Subject: West Virginia University Institute of Technology, Request for additional information concerning application for amendment to license, Control Number: 137512

Re: West Virginia University Institute of Technology
NRC License No. SNM-1990, Docket 07003071

CONFIRMATORY RADIATION SAFETY SURVEY

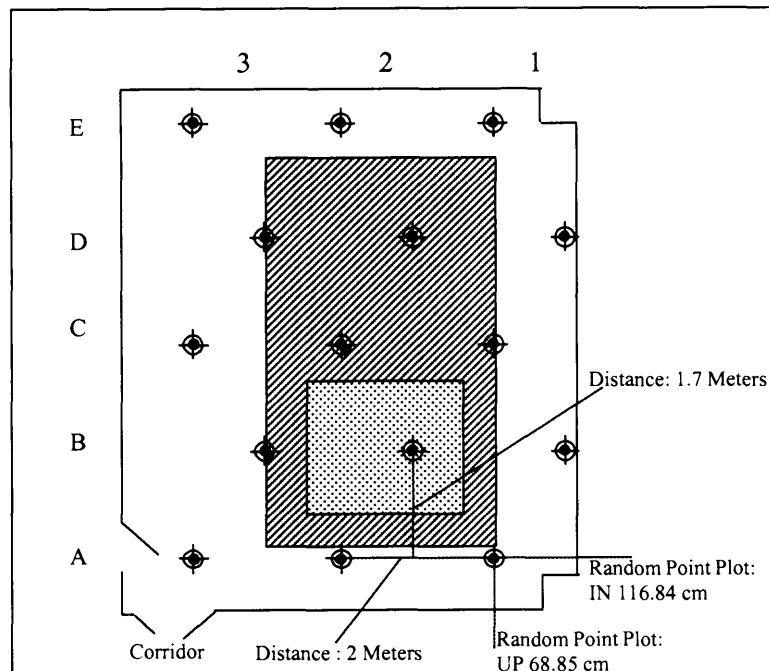
In your response to Item 17.b., you revised the page "Radiation Safety Survey" which lists the static measurements made with the 43-1 probe. However, you did not provide the calculations and instrument data used to determine the results of the static surveys shown on the "Radiation Safety Survey" page. Using the information in the revised "Radiation Safety Survey" page, we still cannot replicate the results. Provide sample calculation which show how you converted the measurement data in cpm to the results in dpm.

Since the confirmatory survey provides more current data, we will use it for demonstration purposes. The data was collected using a Ludlum model 43-90 alpha scintillation detector, which has the following operational parameters:

The results in dpm/100 cm², which using this detector are also dpm/detector, are calculated using the following:

As an example, in the survey document, Grid area (C,2) shows 14 gross cpm. This would produce 0, as shown in the results column.

Note that the minimum detectable activity (MDA) used in the survey is calculated as follows:

Which in this case, would be 79.8 dpm/100cm².
